REMARKS

IN THE DRAWINGS

Please replace the previously filed formal drawings (Figure 1 and Figure 3) with the attached new formal drawings. Two Amended drawing sheets showing changes and two replacement drawing sheets are enclosed.

FIG. 1

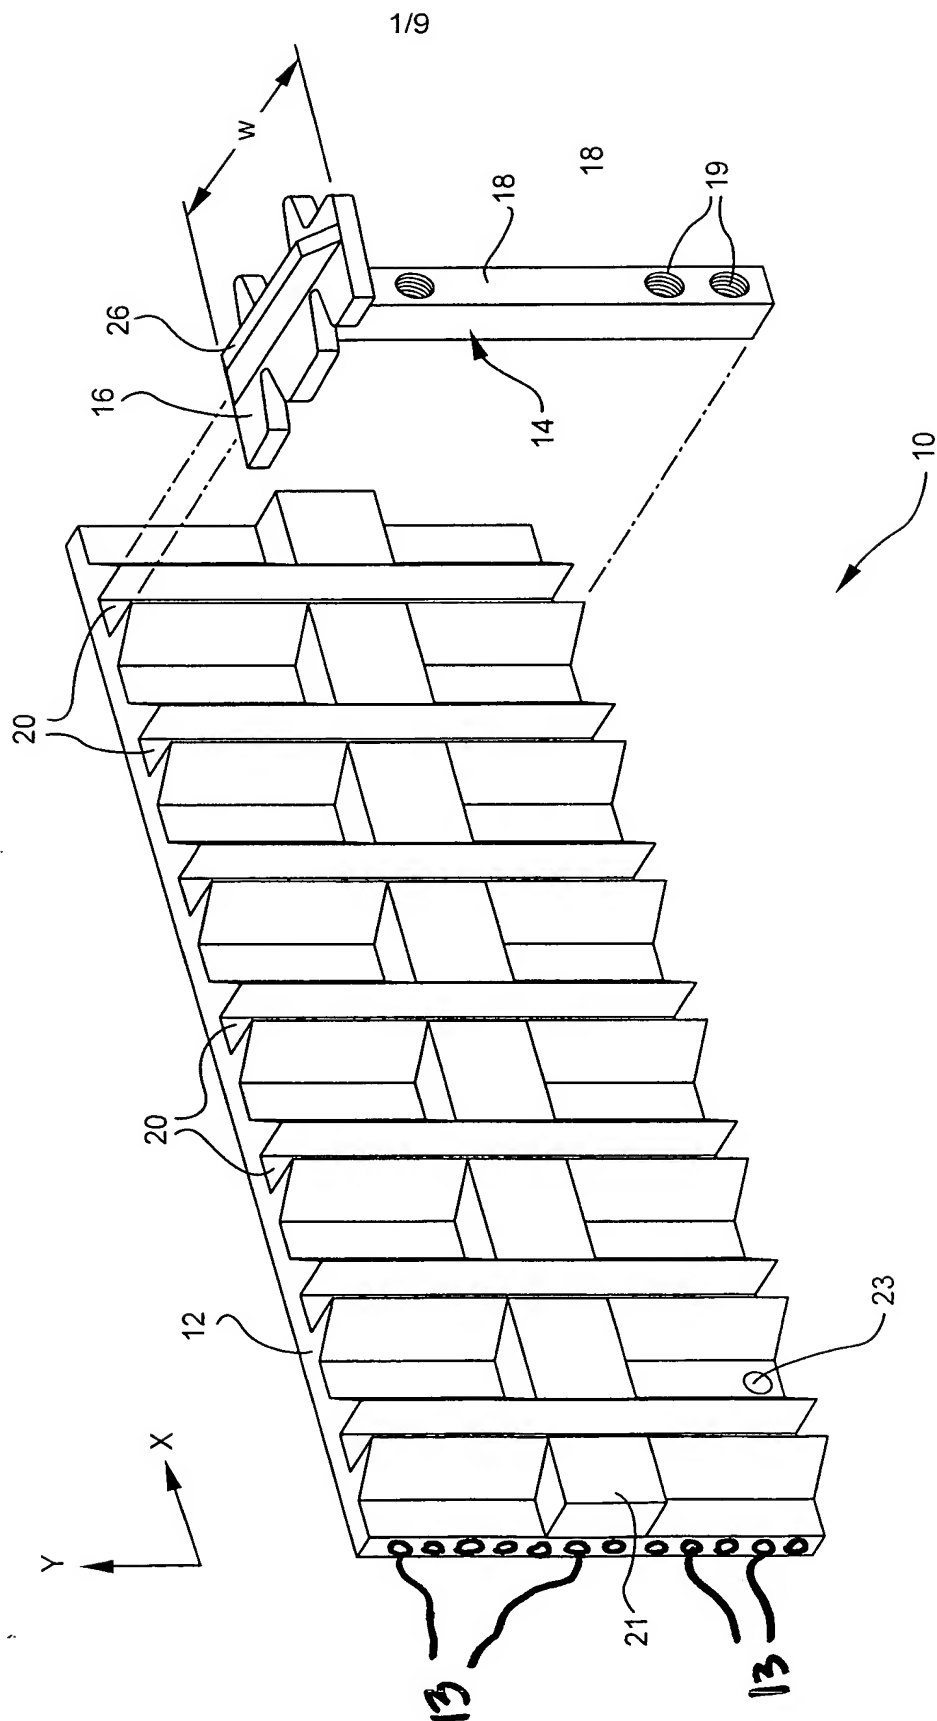
In the Office Action, the drawings were objected to on several grounds. Figure 1 has been amended to show the longitudinal wires 13 running through the belt. No new matter has been added, as the wires were referred to in paragraph 20 of the specification. The drive surface 28 of the vertical portion of the belt is clearly shown in Figure 3, and the sensor opening 23 is clearly shown in at least Figure 5 and amended Figure 3.

Turning now to the objections under 35 U.S.C. 112, first paragraph, Applicants respectfully traverse these rejections. Regarding the plurality of wires, this feature is described in paragraph 20 of the specification and shown in amended Figure 1. The specification has been amended to provide a reference numeral 13 for the longitudinal wires referred to in paragraph [0020]. No new matter has been added. Regarding the portion of the vertical portion of the T-shaped plate providing a driving surface, this feature is described in paragraph 23. The undersigned points out that claim 16 contained a clerical error, and the word "horizontal" has been changed to "vertical". Applicants respectfully submit that this amendment addresses the rejection under 35 U.S.C. 112, second paragraph as well. This amendment was made to correct an obvious clerical error.
